PCN#: Q2092401

DESIGN/PROCESS CHANGE NOTIFICATION -- FINAL

Change Type Description: Alternate Assembly/Test Location/Qualification, Assembly Process, Lead Finish Composition, Package External Dimension

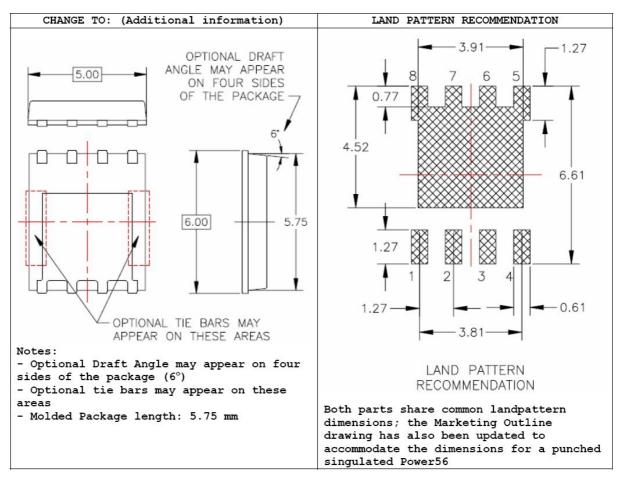
Description of Change (From): Selected MOSFET products currently assembled in Power 56 package at Fairchild Semiconductor in Cebu, Philippines. Current singulation method is Saw Singulation; current plating finish is NiPdAu; and current Die Attach Pad & Leadpost plating is NiPdAu. To view "From/To" Marketing Outline Dimensions, please refer to the attached table "Marketing Outline Dimensions."

Reason for Change: Fairchild Semiconductor intends to qualify GEM Shanghai as an alternate assembly site for Power 56 package to support volume ramp. The Marketing Outline drawing has been updated to accommodate the dimensions for a punched singulated Power56, as illustrated in the table. There will be no change on the Part number as both parts share common landpattern dimensions and thus should be interchangeable from their end. The reference landpattern drawing is shown for reference. Fairchild Semiconductor's selected MOSFET devices assembled in Power 56 package will be affected by this change.

Description of Change (To): Selected MOSFET products assembled in Power 56 package will also be assembled at GEM Shanghai, China. The alternate singulation method will be Punched Singulation; alternate plating finish will be Pure Sn; and alternate Die Attach Pad & Leadpost plating will be Bare Cu.
